802.3dj D2.0

Comment Resolution

Electrical Track

Figure 178-2—200GBASE-KR1, 400GBASE-KR2, 800GBASE-KR4, or 1.6TBASE-KR8 link

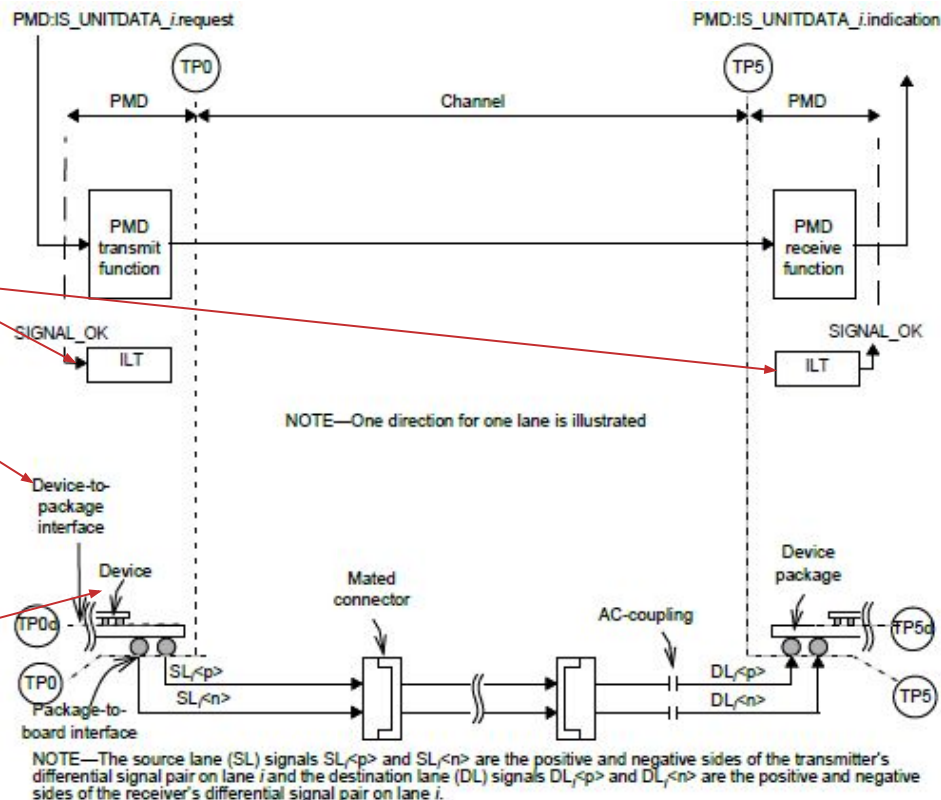
In Figure 178-2 add the ILT function above the PMD transmit and receive functions. Show the SIGNAL_OK as an input to the ILT function at the left side and as an output to the ILT function in the right side (refer for example to Figure 180-2)

Figure 178-2. The interface at TP0 is helpfully labelled as "package-to-board interface". A similar label would be helpful at TP0d.

In Figure 178-2, make the following changes:

Show the PMD ending and "channel" beginning at TP0 and TP5.

Add a label at TP0 and TP5 "MDI".

Change label pointing to the die on the left side of the Figure 178-2 to "Die".

- 92: Add the ILT function & SIGNAL_OK above PMD function.
- 302: ~~Label “Die to package interface at TP0d. Also apply to Figure 176C-2.”~~
- 303: Show channel going from TP0 to TP5. Add “MDI” at TP0 & TP5. (and in Figure 176C-2)
- 304: ~~Change label on die at left from ‘device’ to ‘die’.~~
- 640: Change subclause title. Add sentence to 1st paragraph stating that the PMD is specified at TP0v & TP5v.
 - Note: the MDI is specified at TP0 & TP5 (ref 178.11).

Editor's recommendations: Implement the suggested changes with the exception that “device” not not be changed to “die.”

Figure 178-3—Transmitter test fixture and test points

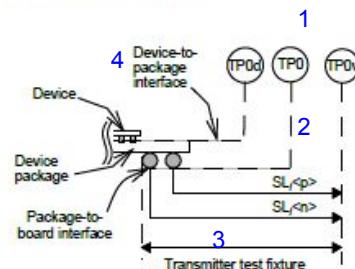
Figure 178-3. It is ambiguous where the test fixture begins. The intent is that the text fixture begins at TP0. Also, it would be good to properly describe the TP0d interface. This figure nor the text definitely define the start and end points of the test fixture.

In Figure 178-3 do the following:

Add test point TP0 at the "package-to-board interface". 1

Add a label at the TP0d interface "die-to-package interface". 4

Updated figures and text.

176D.8.2 Effective return loss (ERL)

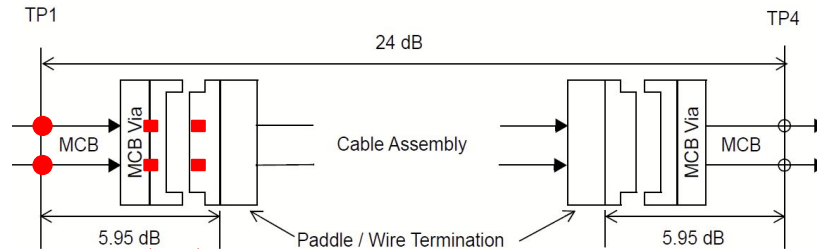
This comment is specifically about the span of Tfx in a cable assembly test fixture (aka MCB).

For host input and output ERL, the test fixture delay is defined as the propagation delay between the test connector and the host-facing connection, excluding the mating interface discontinuity. For module input and output ERL, the test fixture delay is defined as the propagation delay between the test connector and the module-facing connection, excluding the mating interface discontinuity.

This comment seems to address both MCB and HCB.

Figure 176D-5—Module compliance points

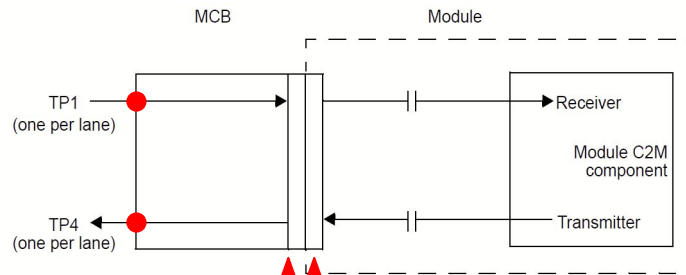
(Top of Figure 179A-1)

- A: MCB connector pads
- B: Receptacle mating point (Cable/HCB pads/Gold Fingers)
- C: Somewhere else?

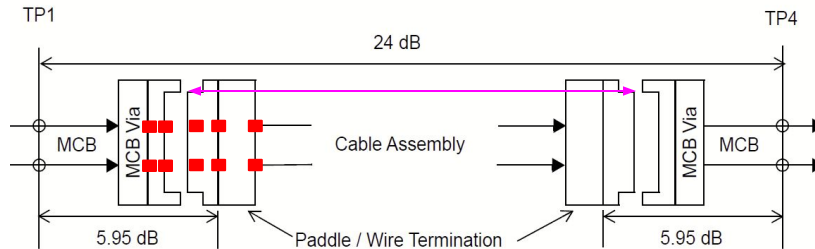
In 176D.8.2 change from:

“For module input and output ERL, the test fixture delay is defined as the propagation delay between the test connector and the module-facing connection, excluding the mating interface discontinuity.”

“For module input and output ERL, the test fixture delay is defined as the propagation delay between the test fixture's coaxial connector and the mating point with a module or an HCB”.

Change other instances of “test connector” to “test fixture's coaxial connector”.

CR Test Fixture

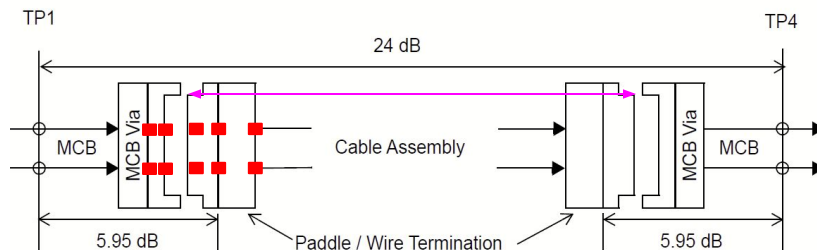
- Is the text “Paddle / Wire Termination” in the Figure clear, and useful?

Cl 179A	SC 179A.5	P 821	L 4	# 658
Swenson, Norman	Nokia, Point2			
Comment Type	TR	Comment Status	D	(Electrical) CR test fixture
What is the extra rectangle labeled Paddle/Wire Termination shown in Fig. 179A-2 that is not shown in the mated test fixtures in Fig 179A-1? It is not explained in the text.				
Suggested Remedy				
Clarify				
Proposed Response

Response Status W				
PROPOSED ACCEPT IN PRINCIPLE.				
The rectangle and labels "Paddle/Wire Termination" serve as demarcation of the cable assembly and the host channel, in Figures 179A-1, 2, and 3. The "Paddle" and "Wire Termination" are structures associated with the cable assembly, and are not necessarily present in an HCB (or Mated Test Fixture). The labels are used to identify specific structures that are not documented elsewhere in the figure.				
These figures provide illustration as appropriate within an informative Annex. Similar figures with the same features are included in in Annex 162A, added by IEEE Std 802.3ck.				
The suggested remedy does not contain sufficient detail for the CRG to discuss a specific change.
